Our Case Number: ABP-318573-23

**Re: A proposed Road Development comprising of the N2 Slane By-Pass and Public Realm Enhancement Scheme
Within the Townlands of Slane, County Meath**

RE: N2 Slane Bypass and Public Realm Enhancement Scheme

Detail of VPT 01, focussing in on the southern approach to the proposed new Boyne Bridge and what appears to be the Rosnaree overbridge: Year 1

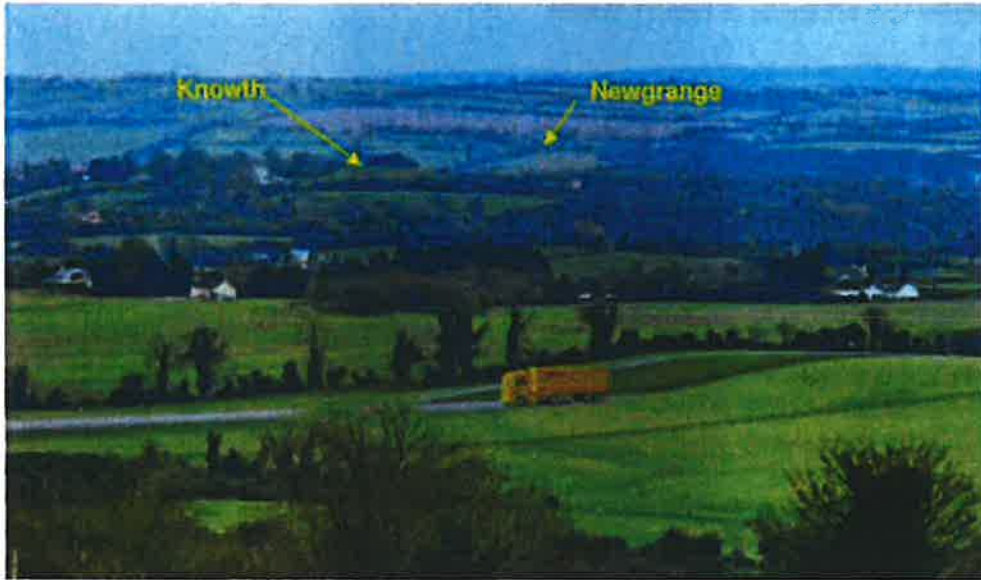
Part of the mitigation strategy is that increasingly, over a period of 10 years, the hedgerow planting with trees will conceal high-sided vehicles on the road to the south of the proposed N2 Boyne Bridge. The OPW notes that the positioning of the proposed N2 Boyne Bridge has reduced the visibility of it to 35 metres on Year 1 of the southern end of the bridge and the southern abutment, reducing to the 25 metres of bridge 10 years later. The 10-year photomontage (VPT 01) demonstrates that it is not feasible to screen the view of vehicles crossing the proposed bridge. It is unclear to the OPW, what a structure at higher level is within the photomontages, possibly the Rossnaree overbridge, which is mostly screened in the Year 10 photomontage. The sinking into a cut of the N2 approach to the bridge reduces the visual impact on Year 1; planting will progressively conceal the upper parts of high-sided vehicles over a 10-year period.

Noise from the existing N2 is currently audible from Knowth under some atmospheric conditions. The proposed road will be closer to Knowth. *Appendix 9.5 Operation Noise Prediction with Mitigation* predicts that noise at R1320 at Knowth will change from 46dB to 47dB.

Views of Knowth and Newgrange in Brú na Bóinne with proposed road in foreground from the Hill of Slane Graveyard, Year 1 (above) and Year 10 (below). Details of Photomontages 17.

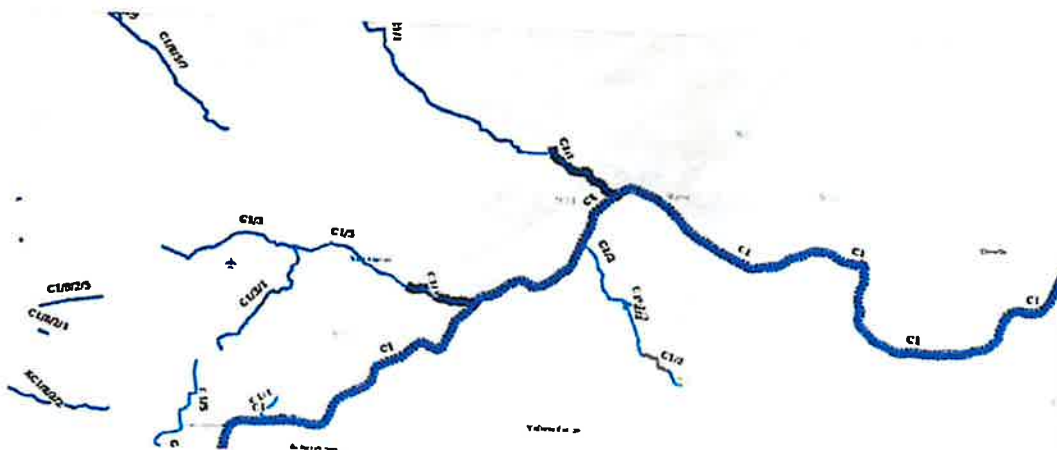
The north section from the N51 roundabout to the north roundabout will be visible in Year 1. The photomontage details below (from the Hill of Slane graveyard and Hill of Slane Carpark) show that the road emerges from a cutting and in Year 1, is exposed on the line of sight between the Hill of Slane and the mounds of Dowth and Newgrange. In addition, there appears to be a lane at a higher level following the existing field boundary/hedgerow. While recognising the importance and statutory protection of the extensive view of the World Heritage Property and its setting from the Hill of Slane, it is the opinion of the OPW that this 'line of sight' element is a particularly important part of that view. This special importance does not appear to be reflected in the HIA description of the predicted change in the two hill of Slane viewpoints: 'short section of bypass with vehicles visible to north of cutting at Norris hill with short section of re-aligned N51 in view looking southeast towards World Heritage Property; North Roundabout with vehicles visible in periphery of view (HIA, p.37).

The scheme includes a proposed mitigation for the north section: the planting of a woodland strip on the west side of the road to reduce, over time, the view of the road from the Hill of Slane. The OPW is concerned that 10 years is a long time for the mitigatory effects of planting to become effective. Indeed the HIA concludes that at 10 years, the upper parts of high vehicles will still be visible, per the photomontages above. It is the opinion of the OPW that pending screening, there will be constant visual distraction in the mid-ground of the view towards the WHP in general, but specifically in the view towards Knowth and Newgrange. The OPW suggests that additional measures are considered, such as berming on the west side of this stretch of road combined with planting and the planting of the central reservation and its maintenance to an agreed height. The possibility of lowering the road in a cutting could also be considered.
